Access Compliance Report

Public Rights-of-Way

(Curb Ramps)

Intersection ID: N/A	Main Street: HORACE_ST	Cross Street: N/A	Location: SW
ADA ID: C2C5B0BFB305	Ramp Type: Perp	Initial Pass/Fail: Fail	Overall Compliance: No
Severity Score: 1.25			
Codes/Mitigation Info/Possible Solution		Field Measurements/Component Compliance

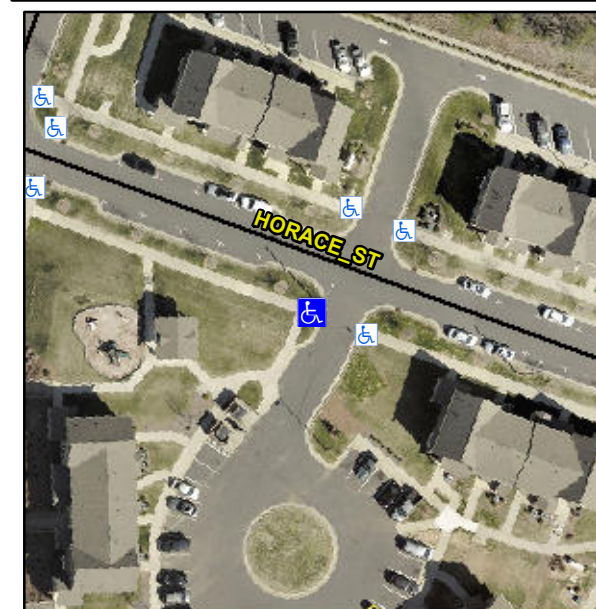
Possible Solutions:

Remove & Replace Entire Ramp.

R304.5.3

Compliance	Description	Data	Compliance	Description	Data
N/A	Ramp Length (in)	73.0	Yes	Ramp Slope (%)	4.1
Yes	Ramp Width (in)	72.0	No	Ramp XSlope (%)	2.3
N/A	Flare Type LT	N/A	N/A	Flare Type RT	N/A
N/A	Flare Slope LT (%)	N/A	N/A	Flare Slope RT (%)	N/A
N/A	Flare Traversable LT?	N/A	N/A	Flare Traversable RT?	N/A
N/A	Landing Length (in)	N/A	N/A	DWS Provided?	N/A
N/A	Landing Width (in)	N/A	N/A	DWS Contrast?	N/A
N/A	Landing Slope (%)	N/A	N/A	DWS Length (in)	N/A
N/A	Landing X Slope (%)	N/A	N/A	DWS Full Width?	N/A
N/A	Landing Curb? (Y/N)	N/A	N/A	DWS Offset (in)	N/A
N/A	Shared Landing?	N/A			
N/A	Gutter Ponding?	N/A	N/A	Gutter Slope (%)	N/A
N/A	Gutter Lip Ht (in)	N/A	N/A	Gutter X Slope (%)	N/A
N/A	Painted X Walk1?	No	N/A	Painted X Walk2?	N/A
	X Walk 1 Direction	To E		X Walk 2 Direction	N/A
N/A	X Walk 1 Width (in)	N/A	N/A	X Walk 2 Width (in)	N/A
	X Walk 1 Slope (%)	4.8		X Walk 2 Slope (%)	N/A
	X Walk 1 X Slope (%)	2.5		X Walk 2 X Slope (%)	N/A
